Docket Item # 12  
BAR CASE # 2009-0299

BAR Meeting  
January 6, 2010

**ISSUE:** Demolition/Encapsulation

**LOCATION:** 804 Wolfe Street

Figure 3. Portion of porch to be enclosed

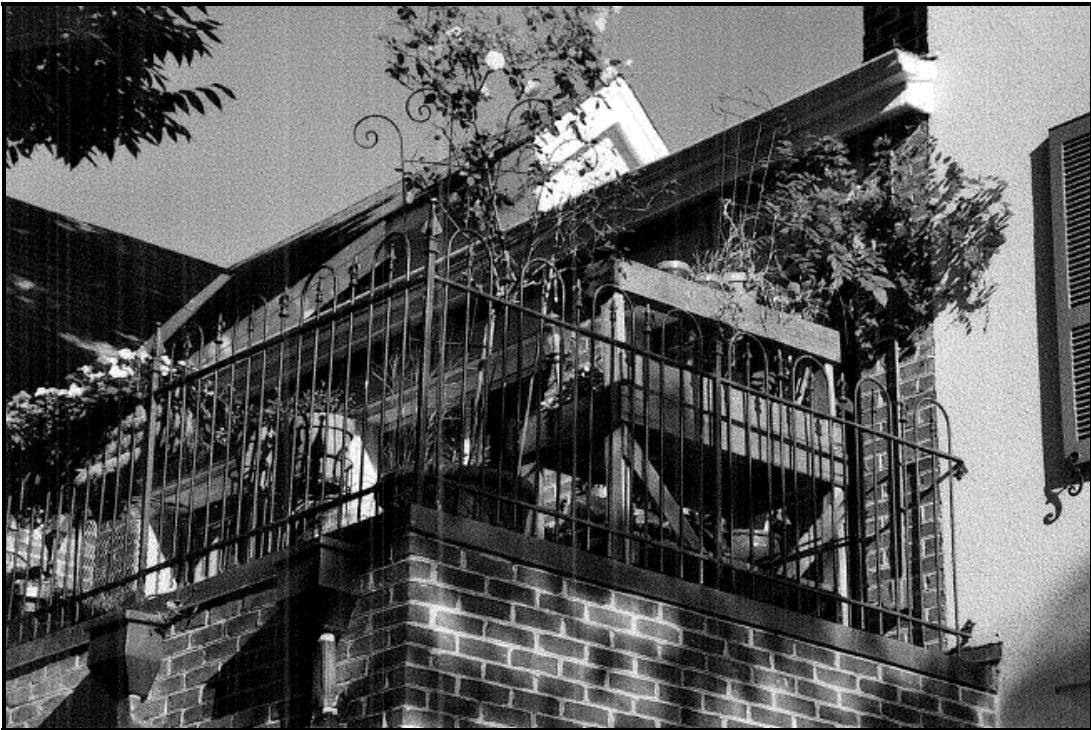
Enclosing the existing second floor open porch on this non-historic building will not negatively impact the integrity of the adjacent historic resources or the district. The existing second floor porch is barely visible from South Columbus Street and is not visible from Wolfe Street. Thus, the encapsulation and new design will minimally, if at all, alter these streetscapes. It is for these reasons Staff recommends approval of the Permit to Demolish/Encapsulate.
